Product Change Notice (PCN)

PCN Number: **PCN-0450073R-01**

Product(s) Affected: **MJ-3536**

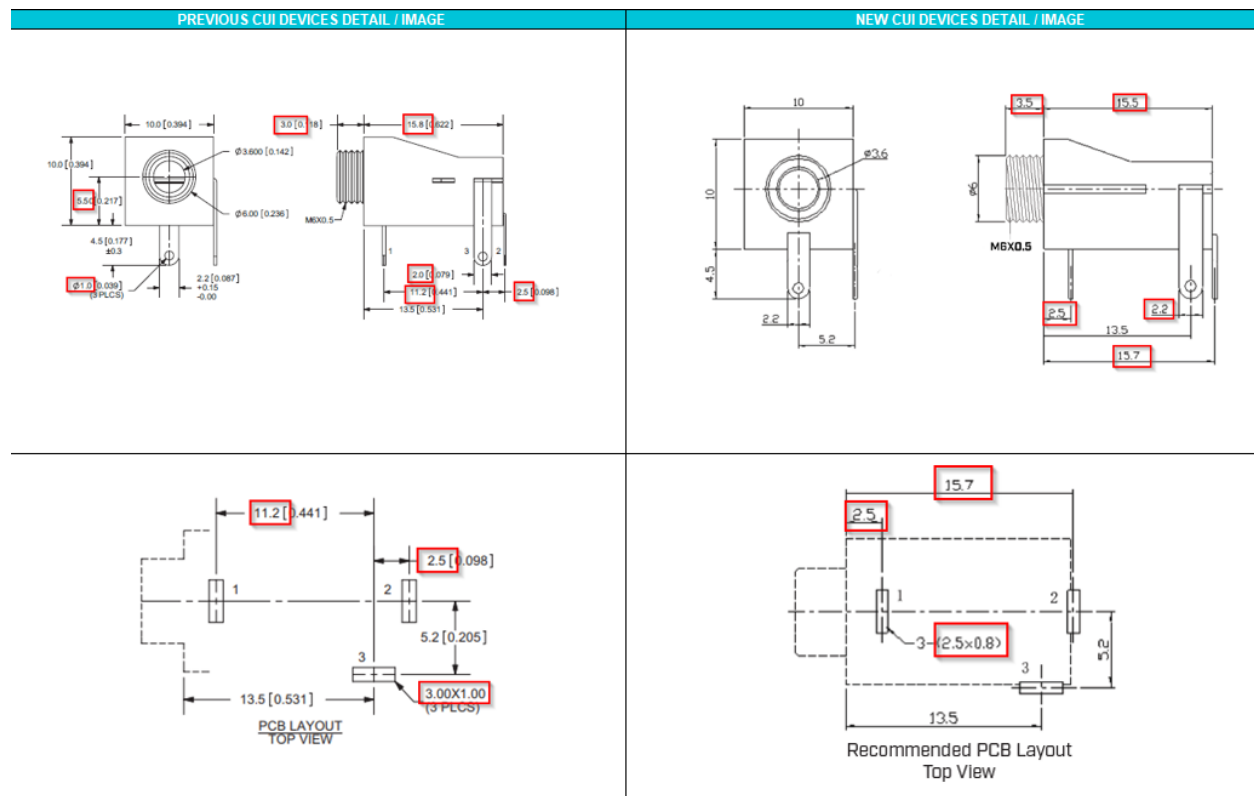
Description of Change: **Minor Housing and footprint differences. Material Change on the housing and terminals. See image Below**

PREVIOUS CUI DEVICES DETAIL / IMAGE			NEW CUI DEVICES DETAIL / IMAGE		
	MATERIAL	PLATING	DESCRIPTION	MATERIAL	PLATING/COLOR
terminal 1	brass	tin	terminal 1	brass	silver
terminal 2	copper alloy	tin	terminal 2	brass	silver
terminal 3	brass	tin	terminal 3	brass	silver
bushing	brass	nickel	bushing	brass	tin
plastic	PBT		housing	PA (UL94V-0)	black
